RECEIPT DATE: 3/23/17 **ONSITE SEWAGE DISPOSAL SYSTEM** P 560581

PROPERTY ADDRESS: 2787 Florence Road

SUBDIVISION: Layton Knoll LOT: 5 TAX ID: 04-596846

RE: 2787 Florence Rd.
Woodbine, MD 21797
"BAT/LPD Plan"

FIGURE 4.1 CENTER FEED MANIFOLD DISTRIBUTION NETWORK

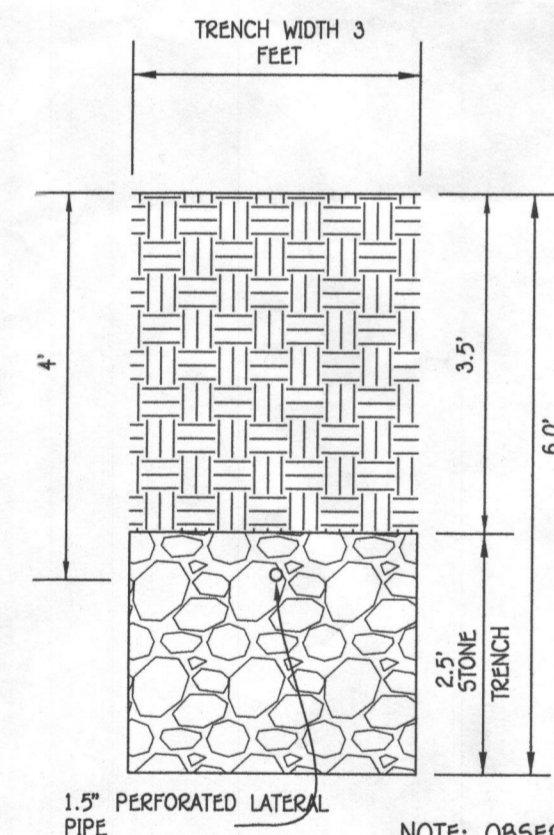
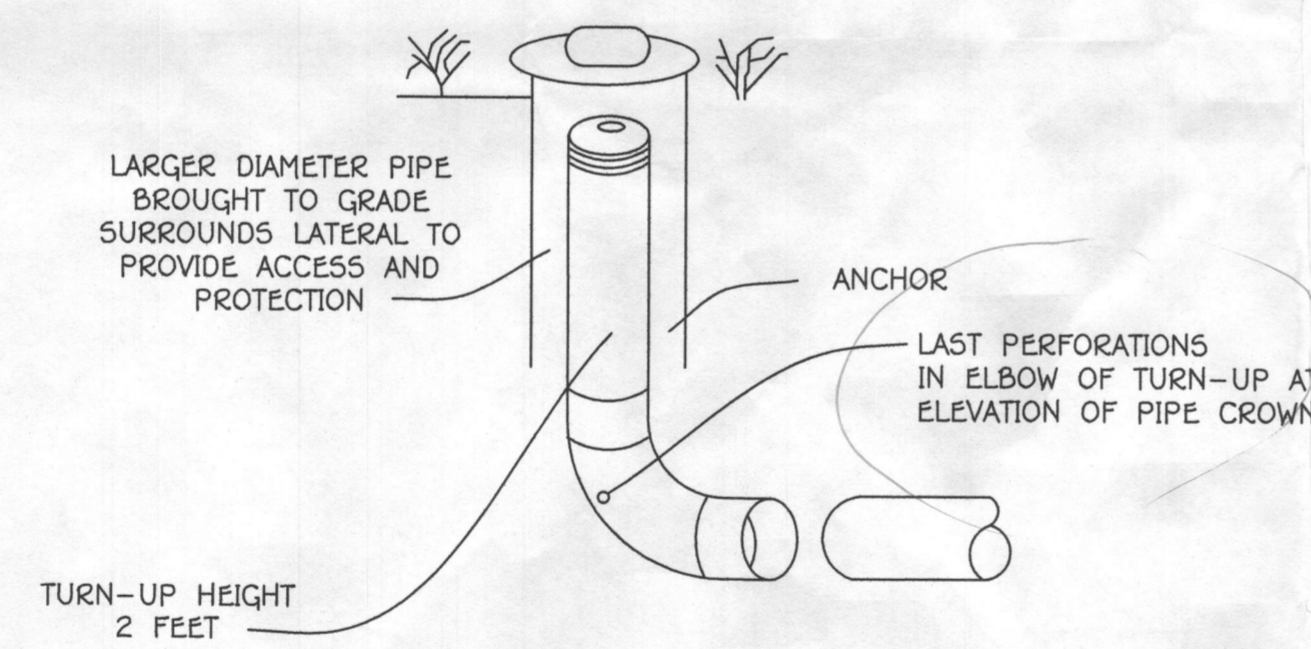
INSTALLATION: 5/1/17 House connection made. BAT tank set. (S) 5/3/17 Pump tank set. Trenches A1 + A2 dug - contractor left 9' solid ground @ pipe inlet depth in center of 88" trench. called engineer and OK to add 2' solid 1.5" pipe to each side of manifold before starting lateral pipe. Also OK to add gate valve. TIA1 + TIA2 3' wide. 8' to bottom TIA2 only 38' - need 6" additional. (S) 5/4/17 Trenches dug, stone added. 3' wide 3.5' to stone. Contractor extended TIA2. No trench observation ports - contractor dug up stone + installed during site visit. Added 3' 1.5" pipe from manifold to each of TIA1 + TIA2 for lateral pipe. Holes measured + drilled while on site. Need pump + alarm and BAT startup certification. (S) 5/17/17 on site for pump + alarm. Alarm sounds, gate valve adjusted so distal head is 3.5' on T1, 5' on T2. Norweco alarm + aerator functional. (S) 5/18/17 BAT startup received. (S)

- There needs to be a weep hole or vacuum breaker on the pump tank.
- If there is a quick disconnect it needs to be shown on the plan and included in the calculations. Contractors typically put these on to make pump replacement a lot easier in the future. If they choose to do this and it is not on the plan they will have to contact you for approval before having you add it to the plan.
- Trench 1A1 and 1A2 should be shown as an 88ft trench if a tee/cross is being used.
- On the 2nd page in the Center Feed Layout Diagram the 44ft Lateral Pipe Length needs to be changed to 41.80 (1A1, 1A2) and 41.25 (1B1).
- On the 1st page the Trench Design Chart needs to specify "Depth to Stone from Ground Surface" and "Starting Effective Depth (From Ex. Ground)."

Per your request, I don't see a problem with the two additional feet of solid 1.5" pipe added from the center to the pipes in each Trench 1A and 1B. Additionally adding the gate valve from the tank on the 2" pipe should also not be a problem. These additions only add around 0.2 ft of head or so. The pump as sized should be able to handle this small amount of additional head.

Detail of pump shown, an overall trench length has been added, lateral pipe lengths have been revised, and column labels have been revised as requested in your comments of 12/15/16.

The union was figured into the comps. I have always been asked to show the trenches as 44 ft each as opposed to 88 feet in the past. I am looking at the plan and the depth to stone is shown along with the effective depth, are you asking me to relabel the columns?
